**BEFORE THE PUBLIC UTILITIES COMMISSION  
OF THE STATE OF CALIFORNIA**

R. 04-01-006

**PROPOSED REVISIONS TO THE LOW INCOME ENERGY EFFICIENCY  
PROGRAM STANDARDIZATION TEAM PROPOSED REVISIONS TO THE  
LOW-INCOME ENERGY EFFICIENCY STATEWIDE POLICIES AND  
PROCEDURES MANUAL AND WEATHERIZATION INSTALLATION  
STANDARDS MANUAL FILED ON NOVEMBER 1, 2005**

March 9, 2006

### 5. APPROVED MATERIALS

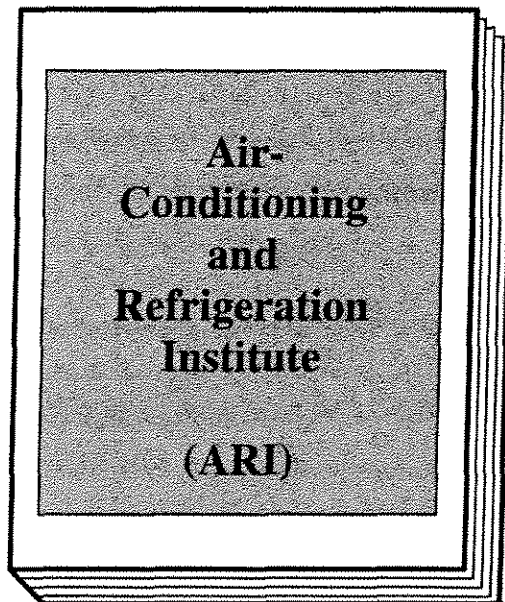
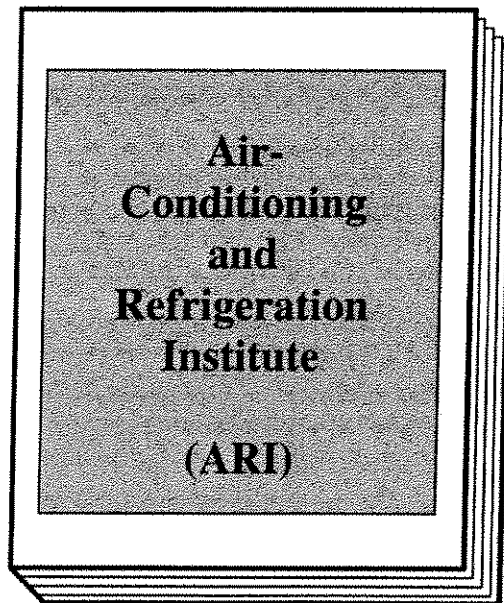
- Minimum SEER of 13.0 and ~~EER of 11.5.~~

- Minimum SEER of 13.0 and ~~EER of 11.5~~ with a Thermostatic Expansion Valve (TXV).
- The SEER shall be determined by the coil match as listed in the current ARI Directory.

- Minimum SEER of 13.0.

- Minimum SEER of 13.0 with a Thermostatic Expansion Valve (TXV).
- The SEER shall be determined by the coil match as listed in the current ARI Directory.
